MIL-C-38271A(USAF)
AMENDMENT 5
7 OCTOBER 1993
SUPERSEDING
AMENDMENT 4
11 Dec 1992

MILITARY SPECIFICATION

CONNECTOR, OXYGEN MASK TO REGULATOR CRU-60/F

This amendment forms a part of MIL-C-38271A, dated 11 March 1968 and is approved for use by all Departments and Agencies of the Department of Defense.

FIGURE 6. Mask port

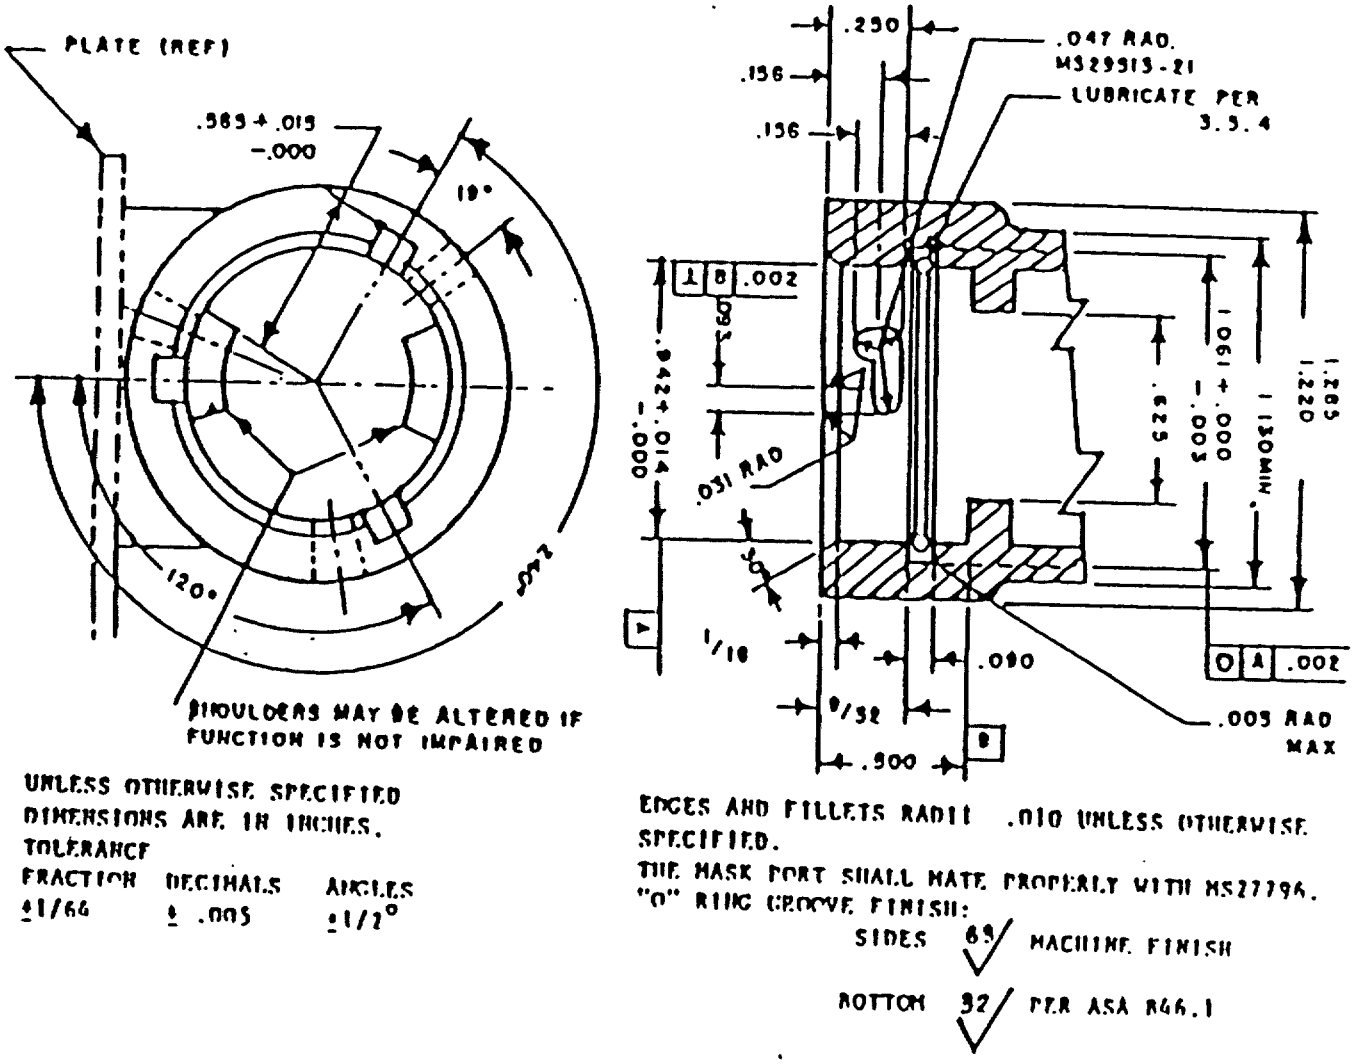
Figure 6: Delete and substitute Figure 6 as shown on Page 6 of this amendment.
